# UNITED STATES PATENT AND TRADEMARK OFFICE

APPLICATION NO.	FILING DATE	FIRST NAMED INVENTOR	ATTORNEY DOCKET NO.	CONFIRMATION NO.
10/733,873	12/10/2003	Gilles Benoit	13445-030001 / L7 (MIT	8066
26161	7590	03/09/2006	10	
FISH & RICHARDSON PC P.O. BOX 1022 MINNEAPOLIS, MN 55440-1022			EXAMINER ROJAS, OMAR R	
			ART UNIT	PAPER NUMBER
			2874

**Office Action Summary**

## **DETAILED ACTION**

**FIG\_1****FIG\_2**

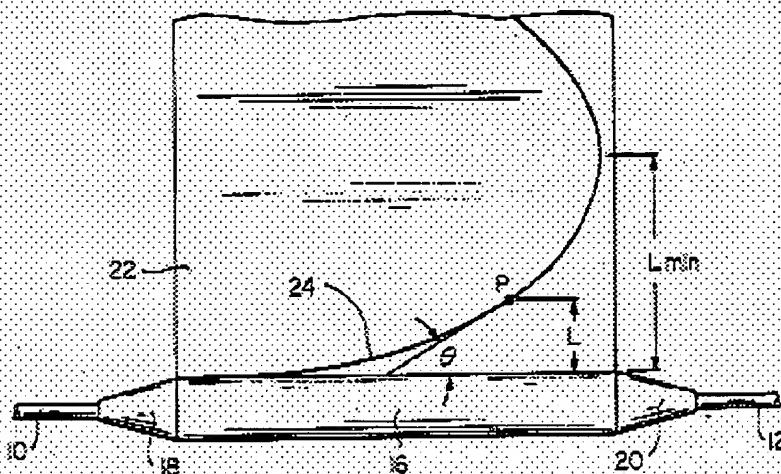
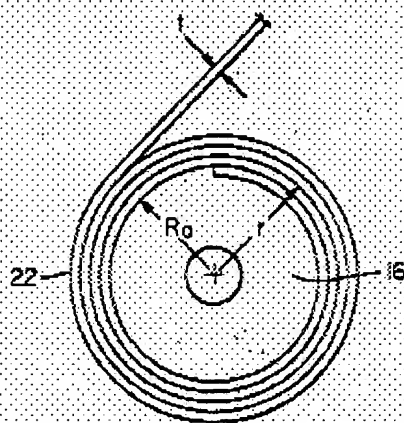
In re claim 26, Fentress discloses an article comprising a fiber waveguide (Figures 1-3) comprising alternating layers (22, 24) of different materials surrounding a core 16 extending along a waveguide axis, wherein the alternating layers (22, 24) define a spiral structure (col. 3, lines 3-10). Figures 1 and 2 of Fentress are reproduced below.

In re claim 27, wherein the spiral structure comprises a multilayer structure comprising at least

two layers (22, 24) of the different materials encircling the core multiple times (see also col. 3, line 54 to col. 4, line 20).

In re claim 32, Fentress suggests that an innermost layer of the one of the alternating layers 22 has a thinner portion than that of subsequent layers of the same material (see col. 3, lines 57-59).

In re claim 36, the core 16 may be hollow (col. 4, ll. 37-39).
